sabena [®] B707	Module: GENERAL	A/C Reg :	Check :	 04G2000500
	Oper. : NRT			
	Type : MODIF	Issuer : A47085	Cert.St.: 24828	Page 1 of 7
Spec. : MECHANIC	Release Date: 02.06.2000

SAB 29-215 rev A Replacement of existing priority valve

FIG 3

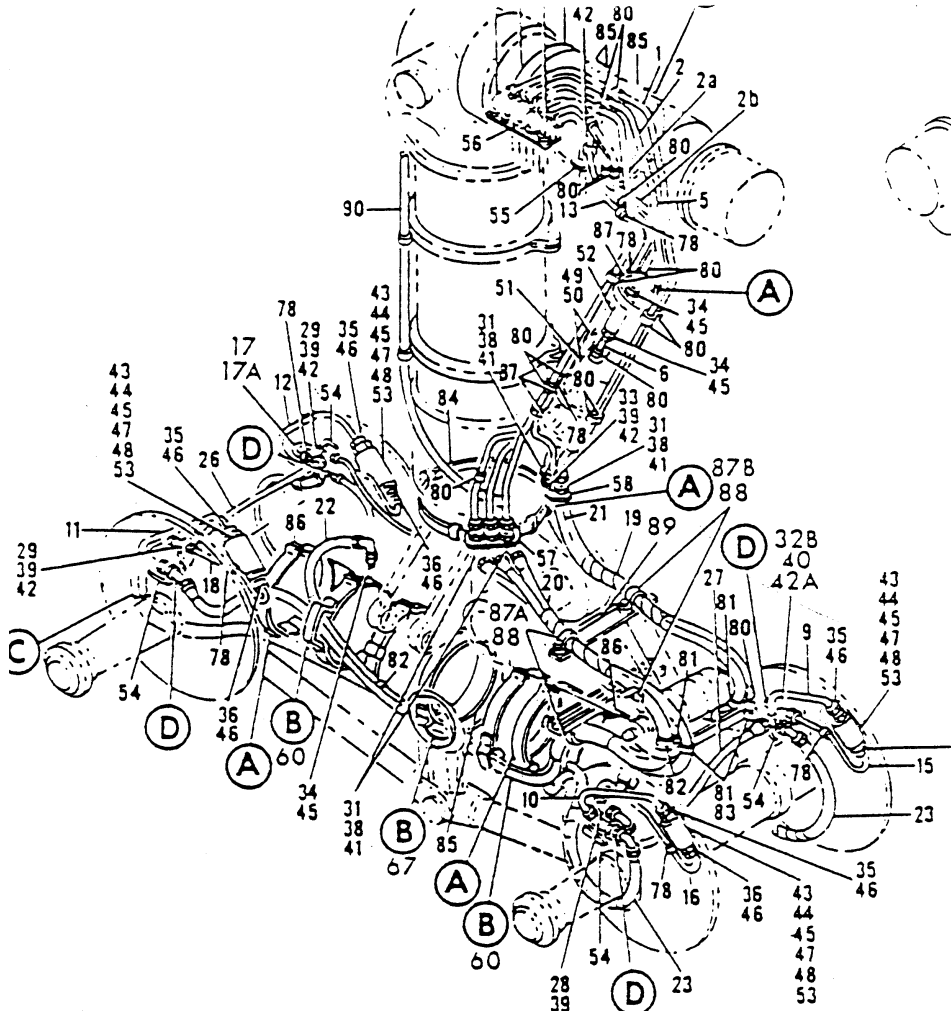
REPLACE OLD P/N <u>A62080-6</u> OR <u>1-74270-6</u> BY NEW P/N <u>1-75596</u>																																													
REPLACE OLD P/N <u>A62080-1</u> BY NEW P/N <u>1-74270-1</u>																																													
Note: If Lufthansa P/N 353-0005 is installed in cargo door system; this P/N is interchangeable with P/N 1-75596 or P/N 72484.																																													
LH installed part	P/N	S/N																																											
RH installed part	P/N	S/N																																											
New LH installed part	P/N	S/N																																											
Tag number:	I/N																																												
New RH installed part	P/N	S/N																																											
Tag number:	I/N																																												
LH installed part	P/N	S/N																																											
RH installed part	P/N	S/N
